Access Compliance Report Public Rights-of-Way (Curb Ramps)

Main Street: OLYMPIA_WAY Cross Street: FAIRHAVEN_AVE Location: SW

ADA ID: RPAT211022090944 Ramp Type: Type 6 - Directional 1 Initial Pass/Fail: Fail Overall Compliance: No Severity Score: 2

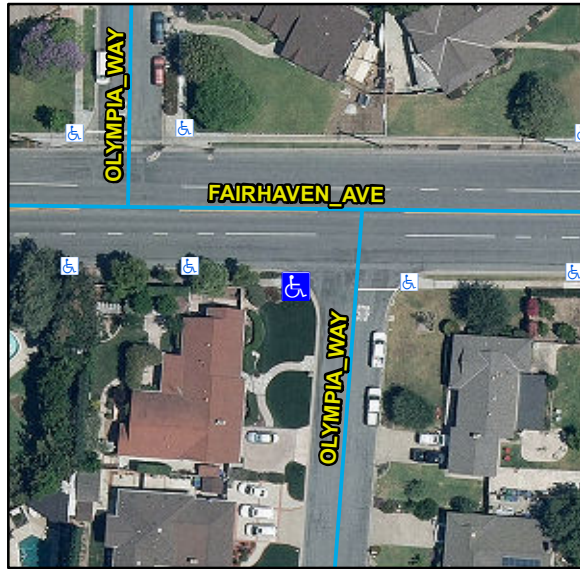
Compliance	Description	Data	Compliance	Description	Data
N/A	Ramp Length (in)	147	N/A	Flare Type LT	
Yes	Ramp Width (in)	64			N/A
Yes	Ramp Run Slope (%)	5.3	N/A	Flare Slope LT (%)	N/A
No	Ramp Cross Slope (%)	2.9	N/A	Flare Traversable LT	N/A
N/A	Grade Break	N/A	N/A	Flare Type RT	
N/A	Grade Break Slope (%)	N/A			N/A
N/A	Grade Break Cross Slope (%)	N/A	N/A	Flare Slope RT (%)	N/A
	Addl Para Ramp Left?	No	N/A	Flare Traversable RT	N/A
	Addl Para Ramp Right?	No	N/A	DWS Provided	N/A
N/A	Landing Present	N/A	N/A	DWS Contrast	N/A
N/A	Landing Length (in)	N/A	N/A	DWS Length (in)	N/A
N/A	Landing Width (in)	N/A	N/A	DWS Full Width	N/A
N/A	Landing Run Slope (%)	N/A		DWS Offset Type	N/A
N/A	Landing Cross Slope (%)	N/A	N/A	DWS Left Offset (in)	N/A
N/A	Landing Movement Obstructed?	N/A	N/A	DWS Right Offset (in)	N/A
	Landing Movement Type	N/A			
N/A	Landing Shared	N/A			
N/A	Marked Crosswalk 1	No	N/A	Clear Space	Yes
	Crossing 1 Direction	SE	N/A	Clear Space To Crosswalk (in)	N/A

Remove & Replace Curb Ramp With Two New Directional Ramps or Equivalent.
